RAPID UPDATE

Rapid Update 673 Grecale – RFHM Software Update

DATE: OCTOBER 24 2023

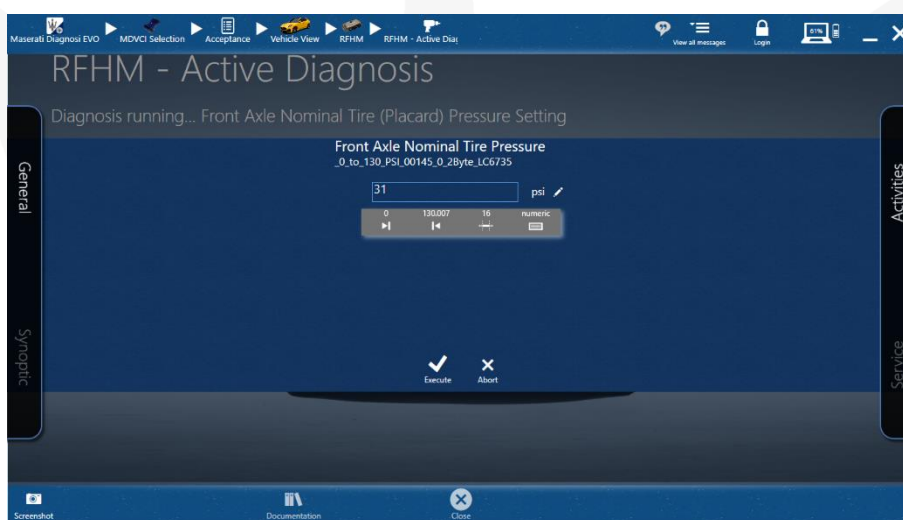
2. Select **Front Axle Nominal Tire (Placard) Pressure** to update the front tires pressure:

3. Insert **31** in the text box and click on **Execute** to set the new value:
